PRODUCT/PROCESS CHANGE NOTICE (PCN)

ATTACHMENT I - PCN #: TB0606-01

PCN Type: Packing

Existing Shipping Tray

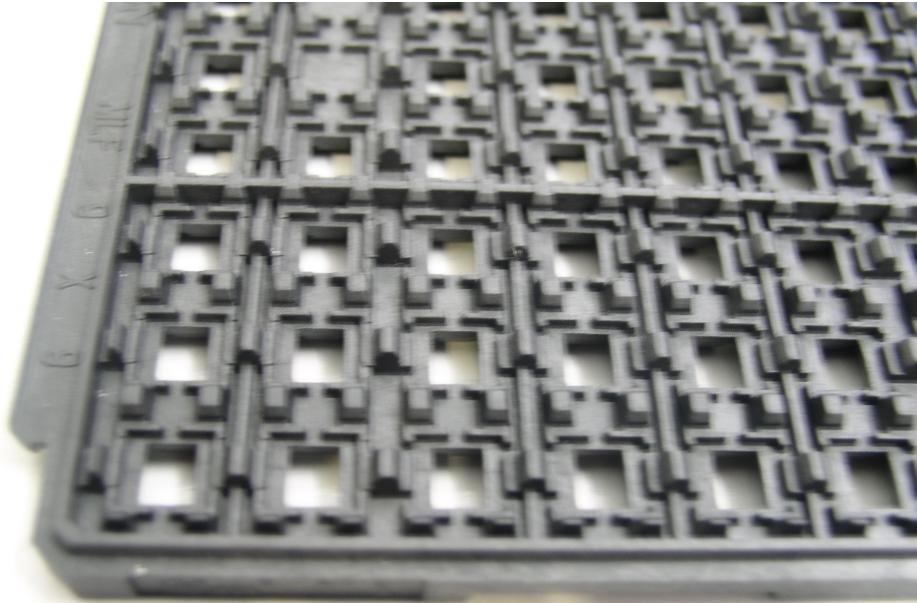
Detail of Change: This notification is to advise our customer that IDT has qualified new shipping trays for VFQFP 64L products. The new trays provide better protection during product shipment.

Please note that there will be a change in number of units per tray from 260 to 207 units/tray. There is no change in the tray dimensions.
